Technical change of the housing of the FrontCom® Micro

PCN-number: PCN-PB47-20230103-00-A
date of publishing: 01.03.2023
duration of validity: until further notice
revision number: 00

Product picture:

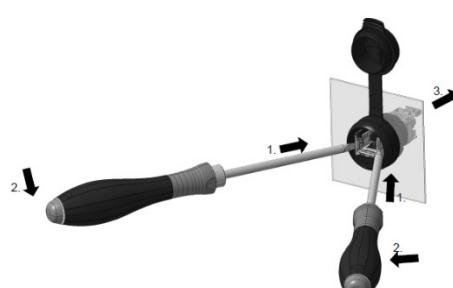
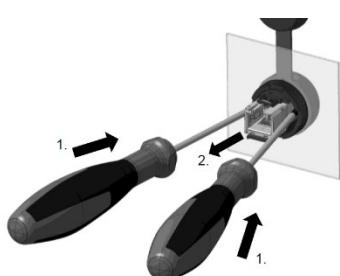
The design on the side of the protective cap including the type of latching of the insert has been adapted. The insert is still mounted from the side without the protective cap, but it is now removed from the side of the protective cap. From there, you have to bend the retaining clips to the side with two screwdrivers as before and can push the insert out backwards. Also the mounting thread has been extended, which now allows mounting with a wall thickness of 1-5 mm.

The modified version provides a tighter fit of the insert in the housing. The disassembly method is easier for the user. The thread extension allows a more versatile use.
